Stage 1 Road Safety Audit

**Phase 1 of Residential Development,
Rosshill, Galway**

On behalf of **Alber Developments Ltd**

July 2021

2.3.2 Existing Rosshill Road / Rosshill Studfarm Road Junction.

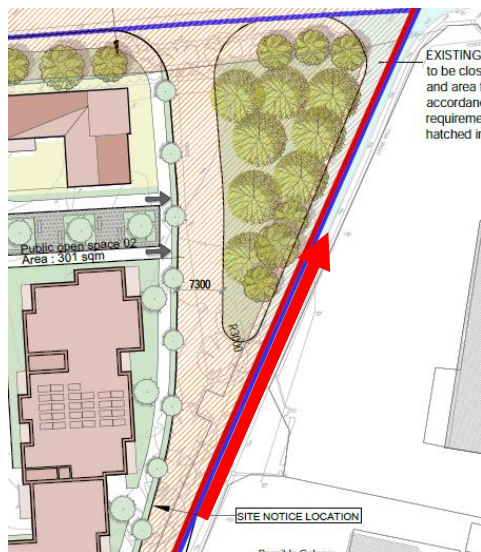
Problem: The proposed new junction is in close proximity to the existing junction.

Hazard: Rosshill Road traffic arriving from the east may errantly turn into the redundant road junction. These users may be required to reverse back onto the public road. Rear-end impacts may result.

Recommendation: Ensure the existing road and junction is removed and suitably landscaped to avoid any confusion that a road exists at this location. However, refer to 2.3.1 above. Ensure adequate signage is provided to inform drivers of new junction layout.

2.3.6 Rosshill Road: Drainage

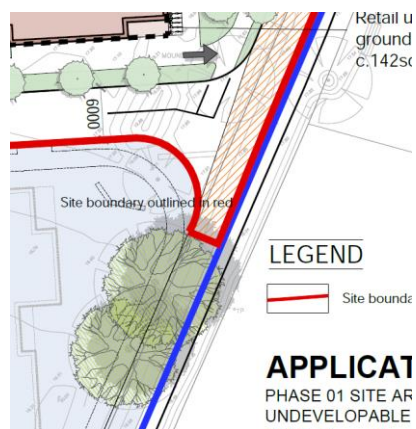
Problem: The existing Rosshill Road drainage is not working adequately. The development will generate increased traffic movements on this road.

Hazard: During times of extreme rainfall standing water may encroach into the carriageway. Risk of vehicular loss of control will be heightened by the increased use of this road.

Recommendation: Ensure adequate surface water drainage is provided.

2.3.8 Re-aligned Rosshill Studfarm Road: Width

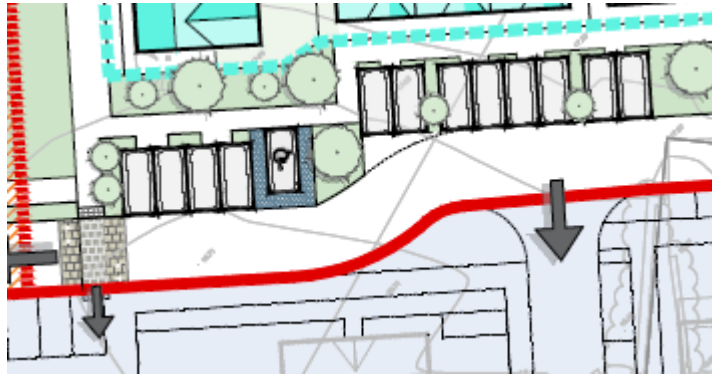
Problem: The realigned Rosshill Studfarm Road seems to reduce in width to the north of the new development junction. Southbound traffic may not expect this road narrowing and keep a uniform distance from the road edge.

Hazard: Impact with users turning out of the development may result.

Recommendation: Ensure a uniform road width is provided between the development access and the junction with Rosshill Road.

2.3.10 No path for disabled parking spaces

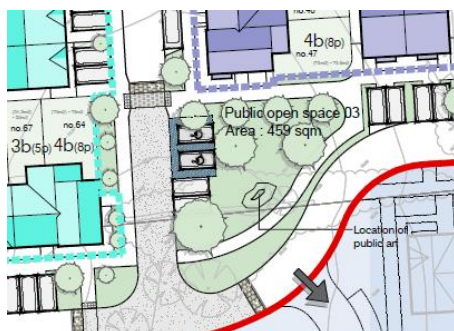
Problem: Safe access/egress from the disabled parking spaces shown below is not proposed.

Hazard: Users may travel in the carriageway and be struck.

Recommendation: Provide a footpath to the front of the parking spaces.
